### ***Attachment C - Summary of Stakeholder Comments***

This summary includes excerpts of stakeholder comments related to Design Guidelines:

**Design Guidelines.** We cannot find an updated version of the Guidelines in the existing package, so we are reiterating the 7-23-12 comments we submitted to staff based on the 7-12 draft. The **attached marked-up pages** include our most significant comments.

Figure A.1: BUILDING LOCATION

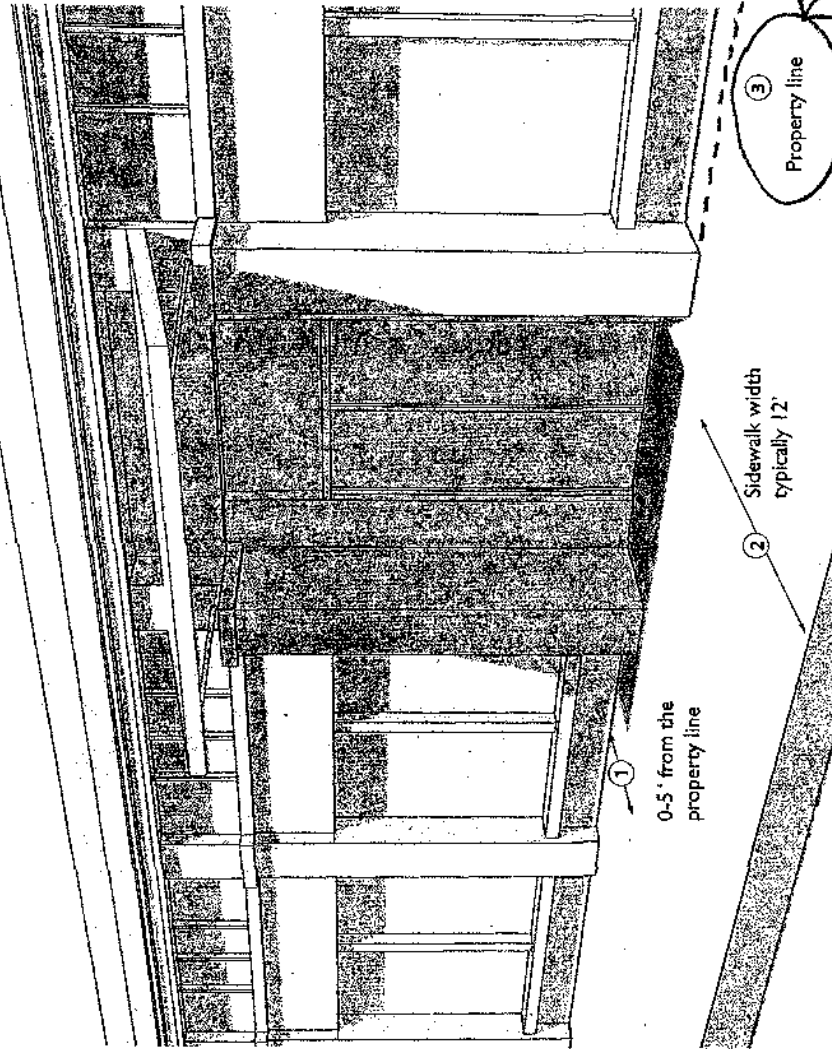
BE CAREFUL WITH THIS  
ENCOURAGE ADDITIONAL SETBACKS WHERE  
WHERE (E) SIDEWALKS ARE TOO  
NARROW (< 12'?)

LIMIT TO A CERTAIN % OF BLDG FRONTAGE, E.G. 30%

Figure A.4: THREE-DIMENSIONAL ARTICULATION

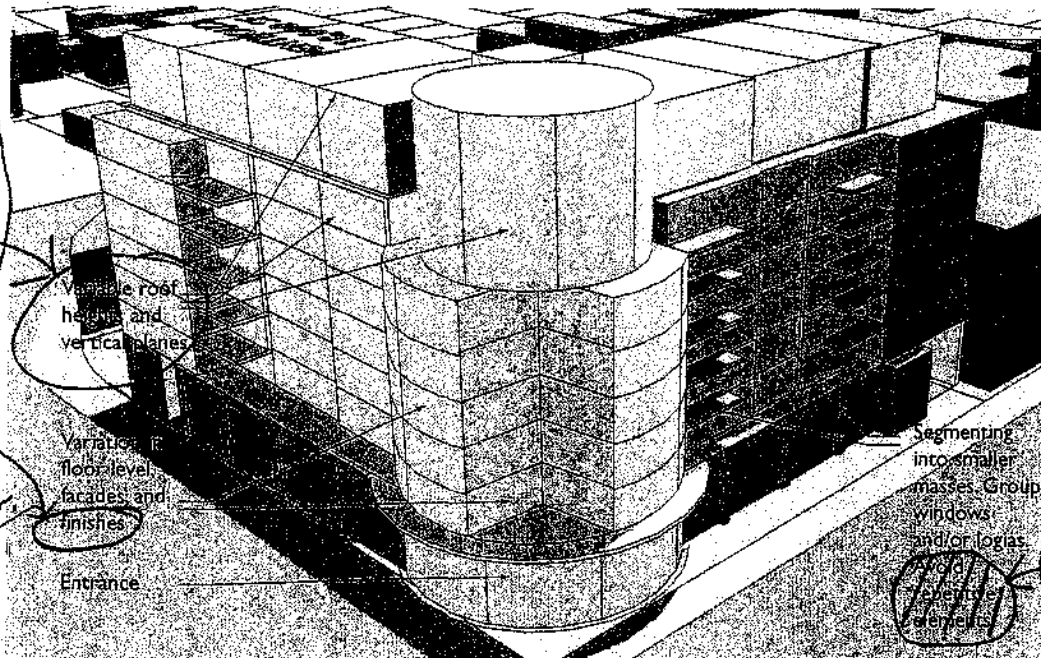
No!  
CORNICES  
RECESSES  
AND OTHER  
HORIZONTAL  
ELEMENTS.  
INCLUDE  
GL STATING  
THIS.

Inconsistent  
w/ OTHER  
GLs.

Figure A.5: TRANSITIONS IN BUILDING HEIGHT

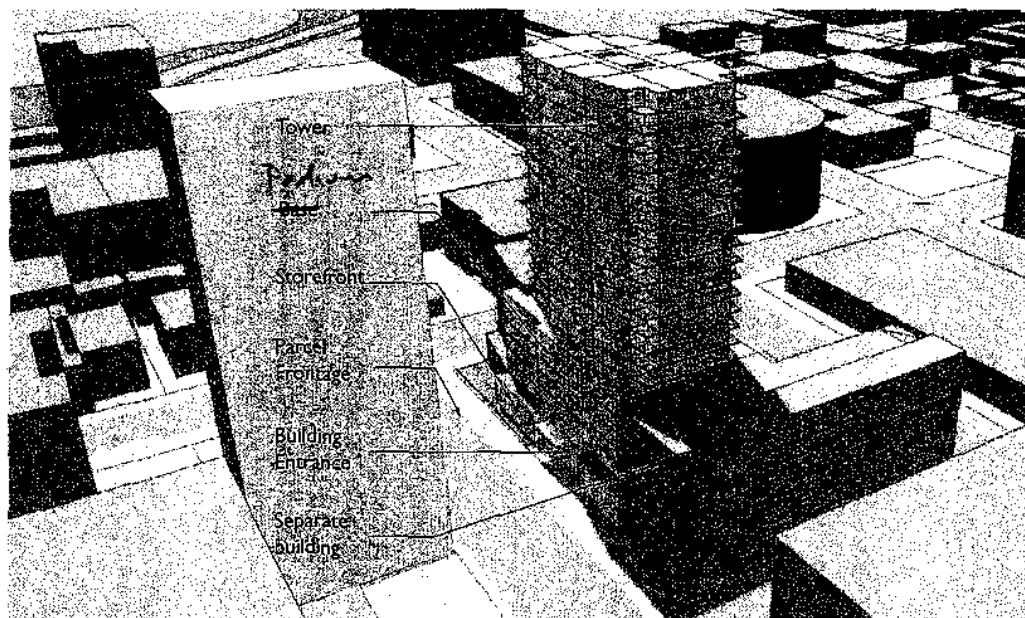
NOT CUPAL  
IS A.5.  
REVISE DIAGRAM  
AND  
RELABEL.  
PHOTOS AT  
BOTTOM OF  
PAGE ARE  
BETTER.

HOW DOES  
VARIABLE  
WINDOW  
HEIGHT  
RESPECT  
SCAPE  
PRIORITY?

Figure A.6: STEP BACK ABOVE THE BASE HEIGHT

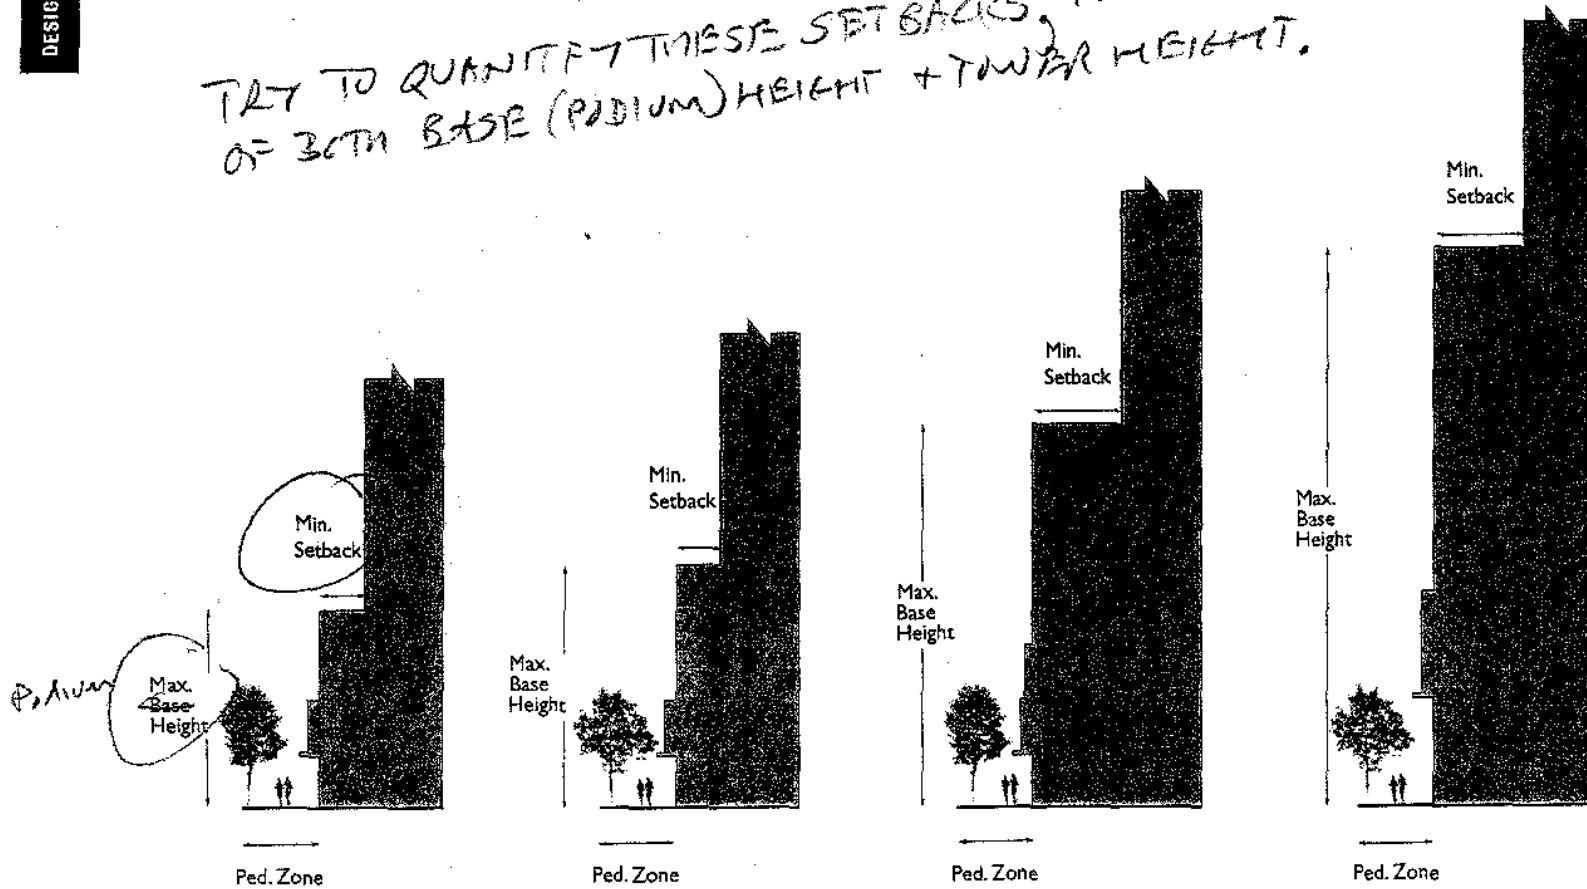
TRY TO QUANTIFY THESE SETBACKS, POSSIBLY AS A PROPORTION OF BOTH BASE (PEDIUM) HEIGHT + TOWER HEIGHT.

These provisions  
should be  
quantified  
in zoning  
standards

not  
GL's

THESE  
PROVISIONS  
SHOULD BE  
QUANTIFIED  
AS ZONING  
STANDARDS

Figure A.6 Step Back Above Base Height - does not include any dimensions or levels! Is this outlined any more specifically elsewhere in the document?

Figure A.8: PEDESTRIAN SCALE ARTICULATION

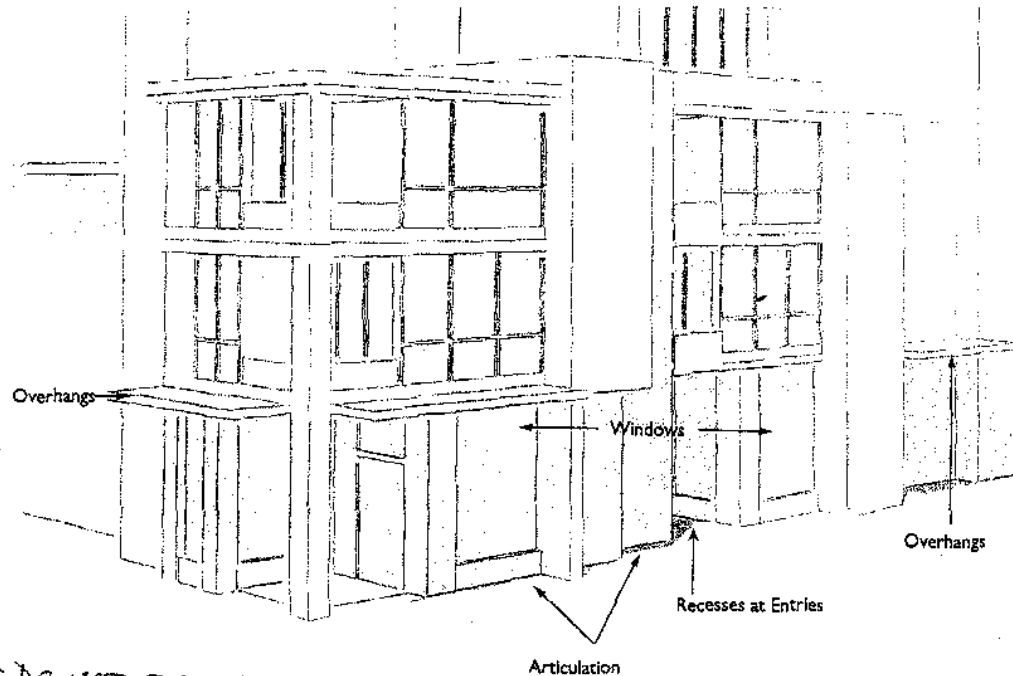
WHERE IS  
THE  
QUANTIFICATION?

DO NOT ENCOURAGE BALCONIES

COULD BE PROBLEMATIC.  
PROVIDE ILLUSTRATIONS.

Figure A.9: STREETWALL

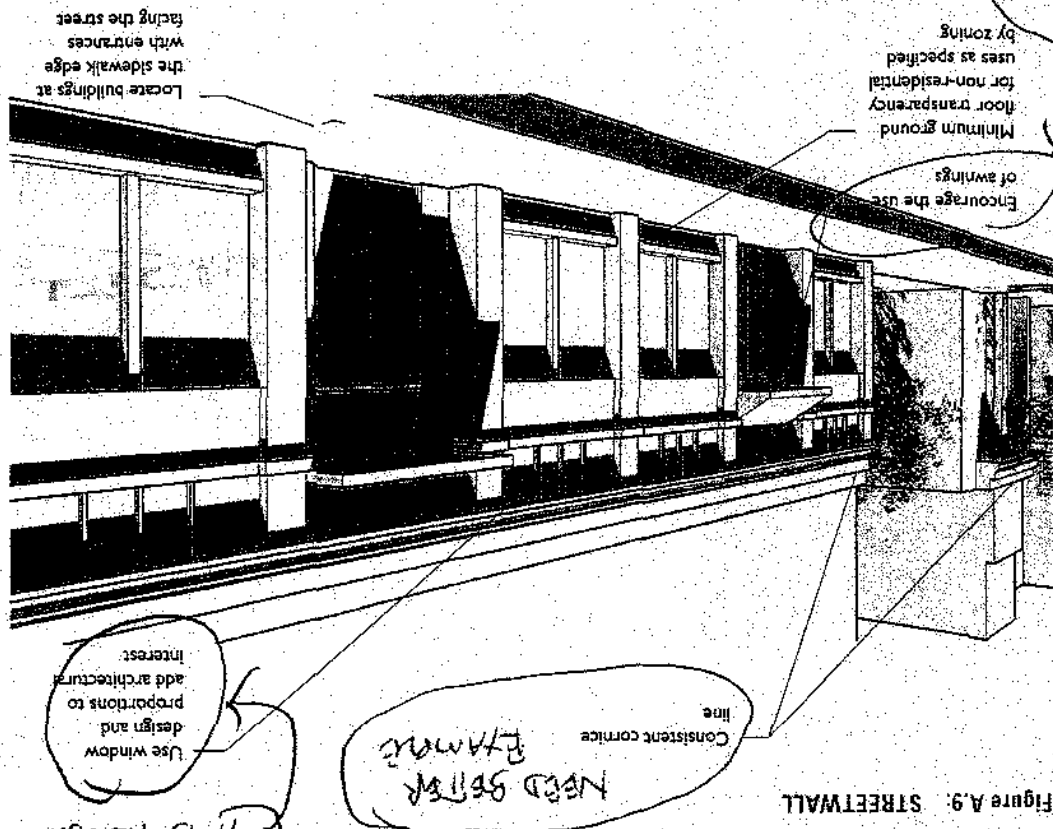
FIGURE A.9 DOES NOT DO THIS ADEQUATELY

VERY

BAD

EXAMPLE.

AWNINGS SHOULD NOT COVER TRANSOM WINDOWS, SHOULD BE SAME STYLE AND IN SAME ALIGNMENT ON THE SAME BLOCK AND SHOULD NOT HAVE EXCESSIVE SLOPED OR VERTICAL SURFACES THAT CAN BE USED FOR EXCESSIVE

Figure A.10: BLANK WALL LIMITATION

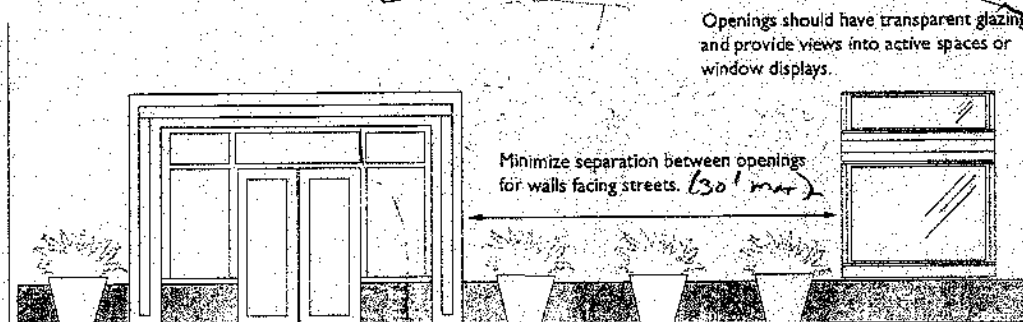
and no more than one-third of a street frontage

Figure A.12: PARKING STRUCTURE ENCAPSULATION

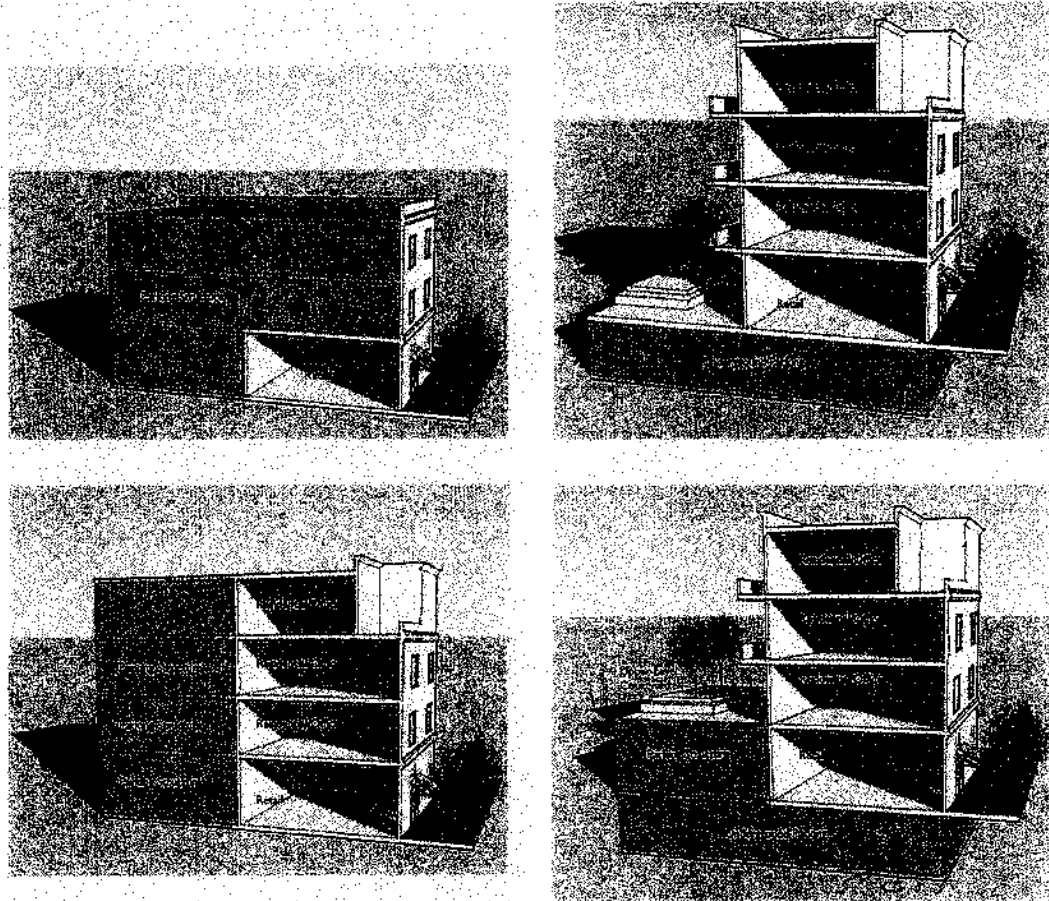
Avoid expressing sloped floors in parking garages on the exterior elevations, eg. provide horizontally aligned opening even where the floors are sloped
